**EASTERN CORRIDOR SEGMENTS II AND III  
Red Bank Corridor to I-275/SR 32 Interchange  
(PID 86462)**

**October 24 and 25, 2018 Public Open House  
CONCEPT EVALUATION and COMMENT SUMMARY**

February 2019

# VILLAGE OF NEWTOWN FOCUS AREA CONCEPTS B3, B4 AND B5, BOARD 10

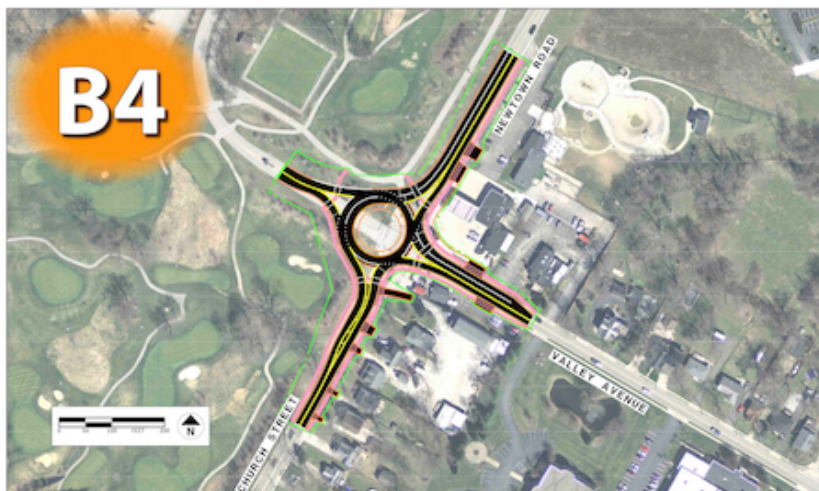
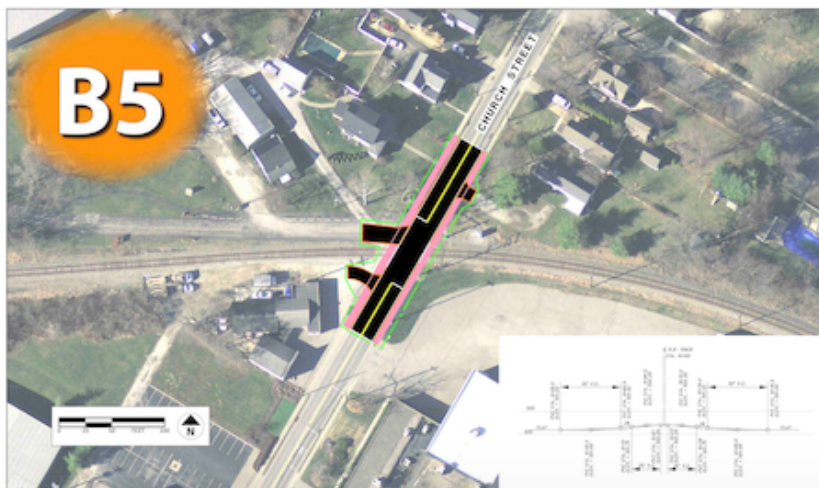
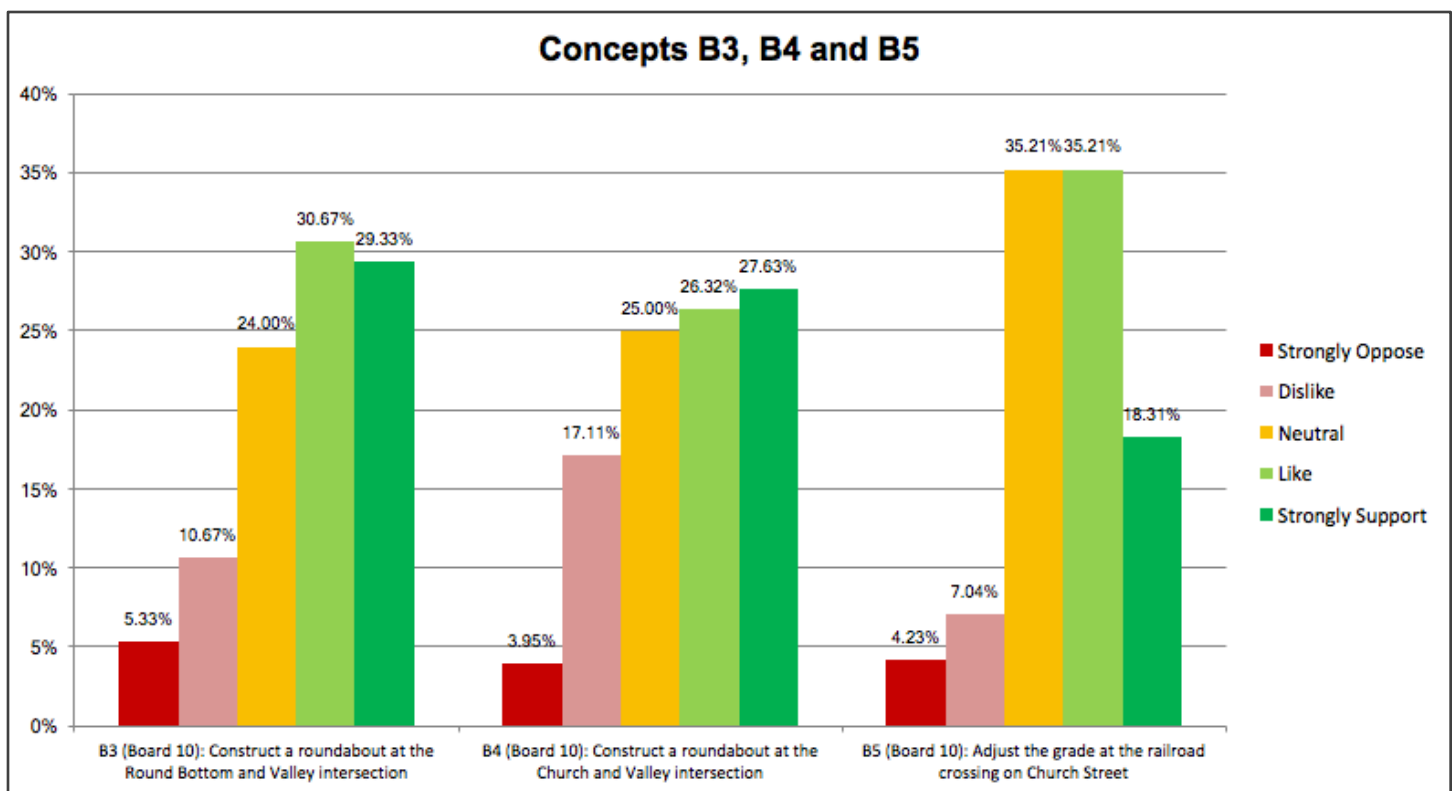
NO.	COMMENT	RESPONSE
1	Regarding B3 - the roundabout is not needed. Installing a better traffic sensor would solve the problem.	Thank you for your comments. Your input is appreciated. Adding traffic sensors to the existing signals is a short-term recommendation of this study and is being pursued. The resulting improvement from that installation will analyzed to determine if this concept would still be needed.
2	Installing roundabouts could impact getting in and out of business along valley and it will make Valley even more traveled and folks will go even faster	Thank you for your comments. Your input is appreciated and will be taken into consideration as we evaluate the options and develop our recommendations.
3	The traffic at Round Bottom and Valley is going to be a disaster! Too many trucks	Thank you for your comments. A roundabout at this location would be designed to accommodate trucks using this intersection.

NO.	COMMENT	RESPONSE
	too sharp of a turn from Valley to Round Bottom going Southbound.	Your input is appreciated and will be taken into consideration as we evaluate the options and develop our recommendations.

NO.	COMMENT	RESPONSE
1	Regarding B4 - same as above [the roundabout is not needed. Installing a better traffic sensor would solve the problem].	Thank you for your comments. Your input is appreciated. Adding traffic sensors to the existing signals is a short-term recommendation of this study and is being pursued. The resulting improvement from that installation will be analyzed to determine if this concept would still be needed.
2	Installing roundabouts could impact getting in and out of business along valley and it will make Valley even more traveled and folks will go even faster.	Thank you for your comments. Your input is appreciated and will be taken into consideration as we evaluate the options and develop our recommendations.

## VILLAGE OF NEWTOWN FOCUS AREA CONCEPTS B6 AND B7, BOARD 11

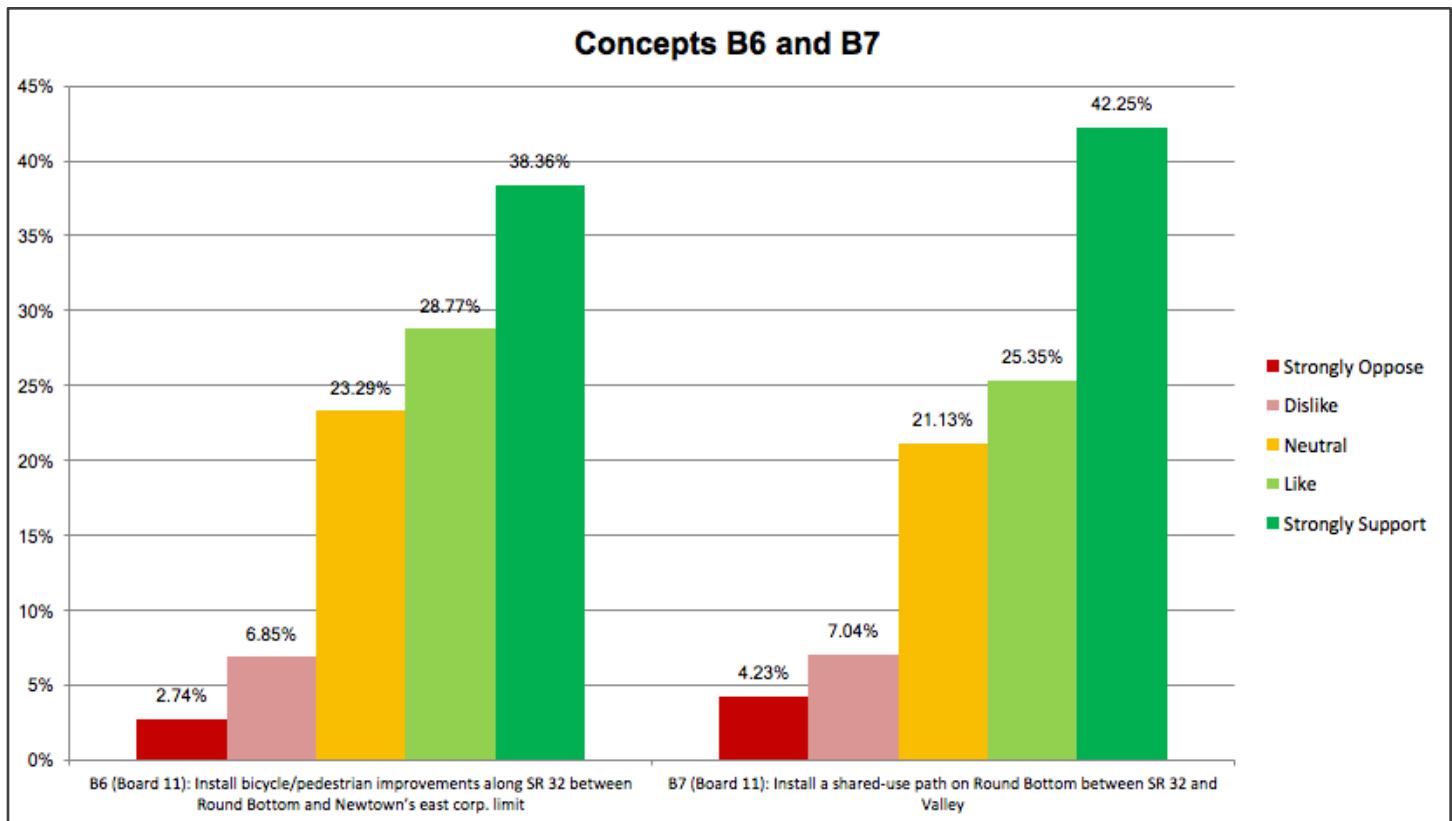
NO.	COMMENT	RESPONSE
1	B6 - Would like to see need assessment	The Eastern Corridor Segments II and III Transportation Needs Analysis Report (July 2017) is posted on the Segments II and III Public Involvement page of the Eastern Corridor website, <a href="http://www.EasternCorridor.org">www.EasternCorridor.org</a> .
2	B6 and B7 - It is unclear who this would serve. Minimal residents and businesses through this corridor that would be benefited by a pathway.	Thank you for your comments. Concepts B6 and B7 were proposed to help address bicycle and pedestrian connectivity needs. More specifically, B6 would provide bicycle and pedestrian connectivity from downtown Newtown to its east corp. limit, connecting users to commercial development at and near Burger Farm and residential communities along Little Dry Run Road.

NO.	COMMENT	RESPONSE
		Concept B7 would improve bicycle and pedestrian connectivity along Round Bottom Road, which also can be connected to additional segments along Valley Avenue or extend on to Riverside Park or Lake Barber.
3	B6 - Strong support for the Little Dry Run to Round Bottom section. Little Miami Trails - couldn't easily connect to Anderson Trails project with this piece of the project.	Thank you for your comments. It should be noted that projects such as B6 would serve as smaller pieces of a larger connectivity effort that has to be constructed in stages due to funding limitations
4	I live in Williams Creek, which connects through Ivy Hills to a sidewalk along Little Dry Run. The sidewalk leads to the Clark Station on SR32. We feel isolated from the business Districts in Newtown & Anderson. Bicycle and pedestrian improvements along SR32 B6 would be wonderful!	Thank you for your comments. Your input is appreciated and will be taken into consideration as we evaluate the options and develop our recommendations.

5	<i>Received via email:</i>  We support the creation of sidewalks and trails connecting Little Dry Run to the village of Newtown!	Thank you for your comments. Your input is appreciated and will be taken into consideration as we evaluate the options and develop our recommendations.
6	<i>Received via email:</i>  Hello. I just wanted to provide my full support of a sidewalk on 32 connecting Little Dry Run to Round Bottom. I frequently run along this path on the side of the road, and feeling safer while doing so would be great. My kids have asked to walk to Dairy Corner but I always tell them we can't due to no sidewalk. Looking forward to hearing how this progresses.	Thank you for your comments. Your input is appreciated and will be taken into consideration as we evaluate the options and develop our recommendations.
7	<i>Received via email:</i>  My husband and I frequently run from little dry run to Newtown, in order to get to the trails along Bass Island and Short Park. We would be elated to have shared use paths that connect Little Dry Run to Round Bottom. There is also a running group that is based around Newtown but either runs in Anderson, or Mariemont because it's too dangerous to use the grassy area along 32. Fingers crossed this will happen!!  <i>Follow up message received:</i>  I just sent a message about sidewalks from Little Dry Run to Round Bottom along 32,	Thank you for your comments. Your input is appreciated and will be taken into consideration as we evaluate the options and develop our recommendations.

NO.	COMMENT	RESPONSE
	but I think I used the subject B8. Just wanted to confirm I was intending to speak about B6.	
8	<p><i>Received via email:</i></p> <p>We support the creation of sidewalks and trails connecting Little Dry Run to the village of Newtown!</p>	Thank you for your comments. Your input is appreciated and will be taken into consideration as we evaluate the options and develop our recommendations.
9	<p><i>Received via email:</i></p> <p>Hi, I live off of Little Dry Run (Village Drive) for three years, and I pray for my life when I attempt to run or walk from Little Dry Run (Circle K) and travel west to downtown. I currently have no sidewalk access to make it to the traffic light at the Ivy Hills apartments. I would love to be able to walk to downtown Newtown on a sidewalk and not fear for my life by walking on Rt. 32 west.</p>	Thank you for your comments. Your input is appreciated and will be taken into consideration as we evaluate the options and develop our recommendations.

NO.	COMMENT	RESPONSE
1	B6 and B7 - It is unclear who this would serve. Minimal residents and businesses through this corridor that would be benefited by a pathway.	Thank you for your comments. Concepts B6 and B7 were proposed to help address bicycle and pedestrian connectivity needs. More specifically, B6 would provide bicycle and pedestrian connectivity from downtown Newtown to its east corp. limit, connecting users to commercial development at and near Burger Farm and residential communities along Little Dry Run Road. Concept B7 would improve bicycle and pedestrian connectivity along Round Bottom Road, which also can be connected to additional segments along Valley Ave or extend on to Riverside Park or Lake Barber.

## CONCEPTS C1 AND C2, BOARD 14

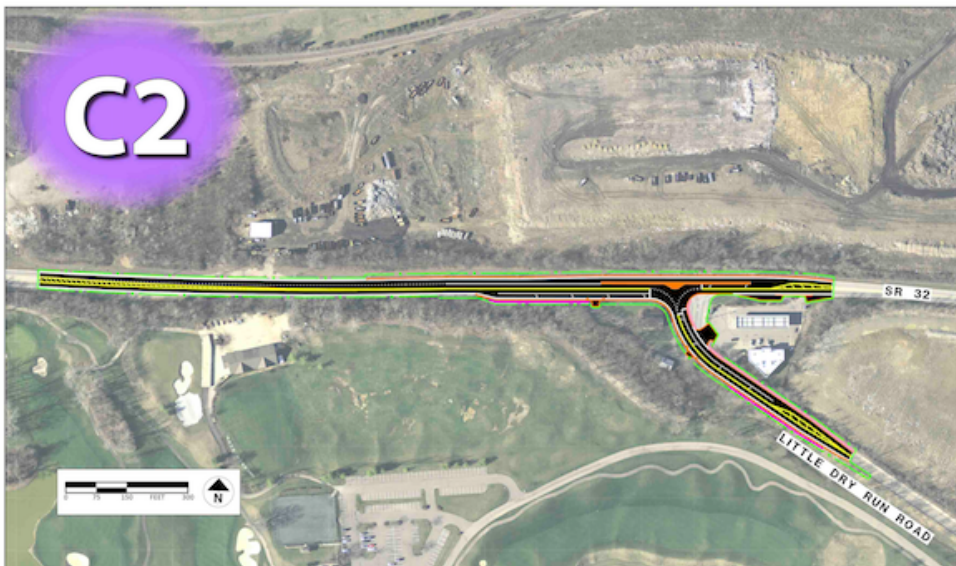
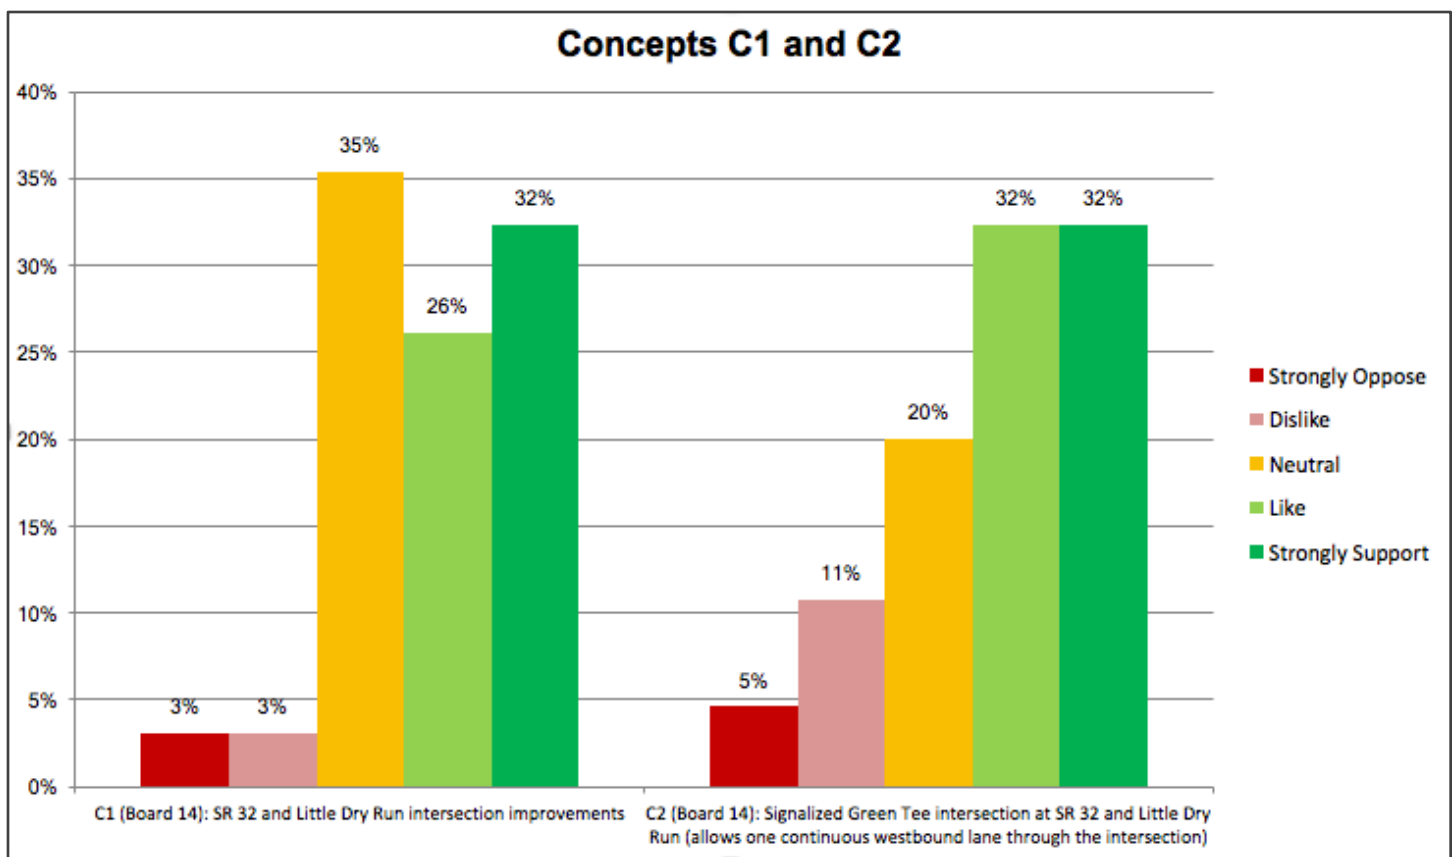
NO.	COMMENT	RESPONSE
C2	This would make it way too difficult for traffic coming from Little Dry Run to merge with the huge volume of traveling on westbound 32 during rush hour.	Thank you for your comment. Your input is appreciated and will be taken into consideration as we evaluate the options and develop our recommendations. While this project stands alone, we are considering issues in the corridor when evaluating project priority. This project would not likely be constructed until an improvement at SR-32 & Round Bottom is constructed first.

## ANCOR/SR HILL FOCUS AREA CONCEPTS C8 AND C9, BOARD 17

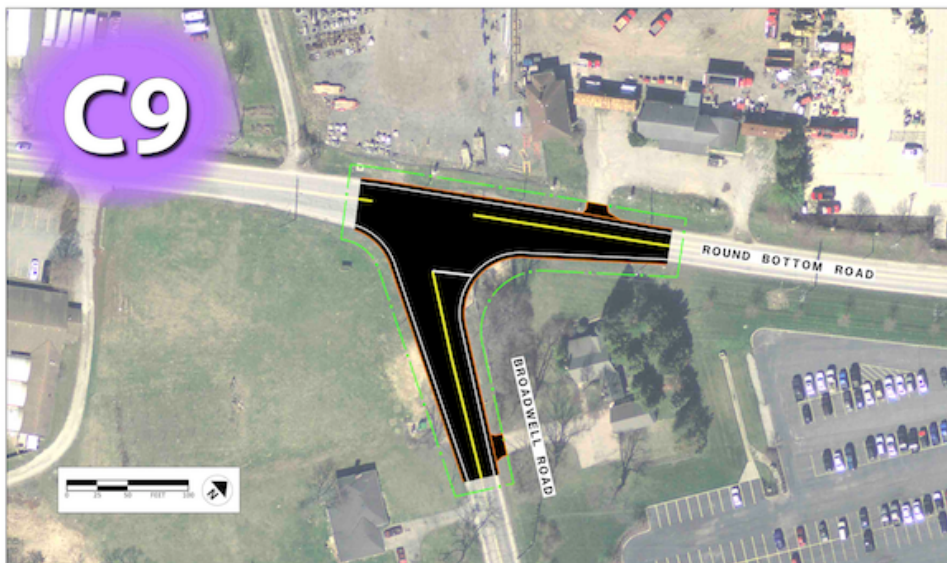
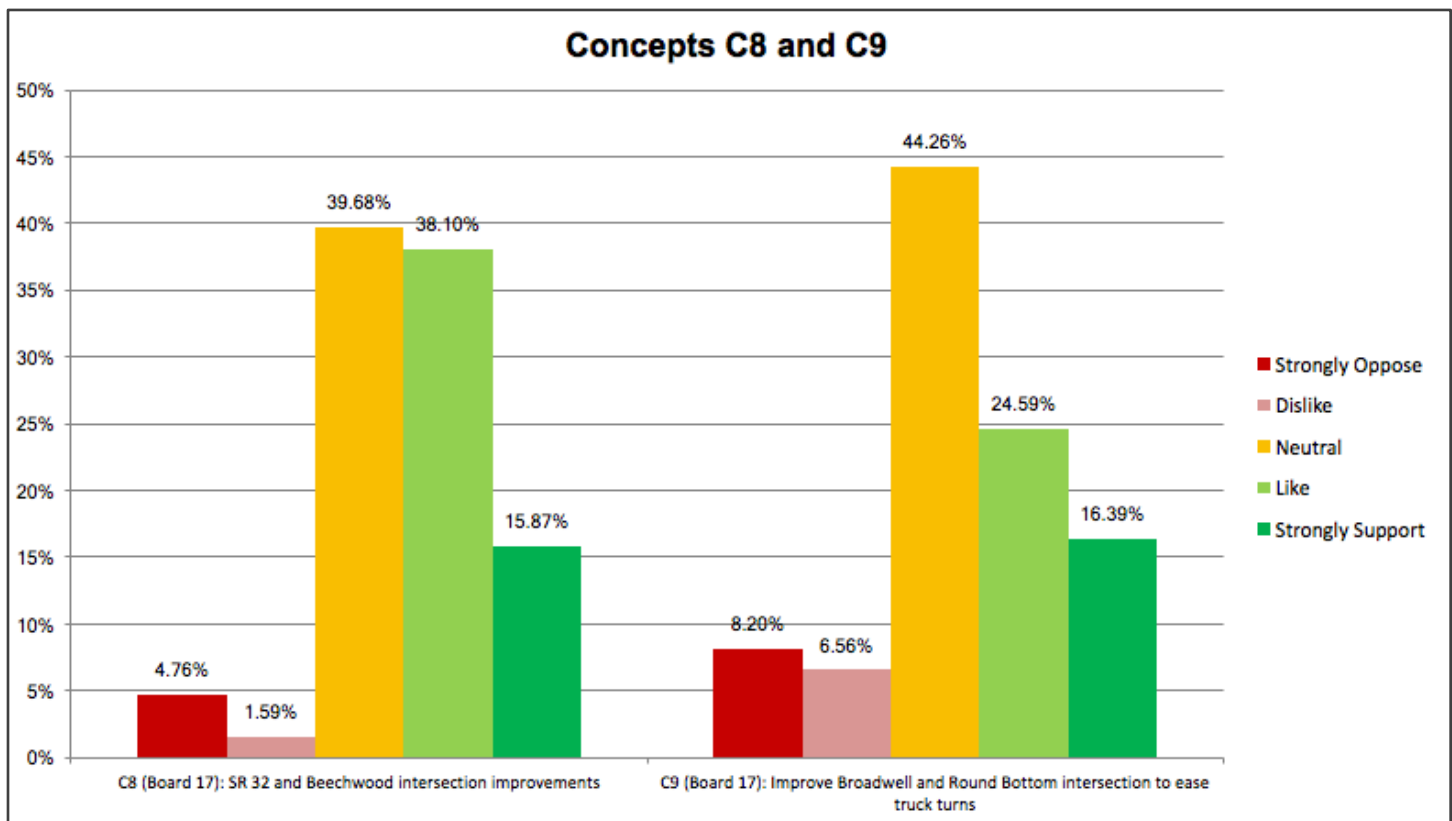
NO.	COMMENT	RESPONSE
1	C8 - Improvements identified in your plan do NOT include a dedicated westbound turn lane onto Beechwood (BUT SHOULD), noting extra pavement exists and a "do not drive on marked shoulder" signage in place prohibits usage - THIS SHOULD BE A "NO BRAINER," and it appears you missed it (very limited cost, but big improvement potential).	Thank you for your comments. We appreciate the idea you have suggested and have evaluated whether a dedicated right (westbound) turn lane onto Beechwood should be implemented in this location. Based on our traffic data, we have determined that there will be a 10% benefit to the overall delay at the intersection during the PM peak hour. Therefore, we will include a right turn lane onto Beechwood in the Implementation Plan.
	Thanks for your work and consideration!
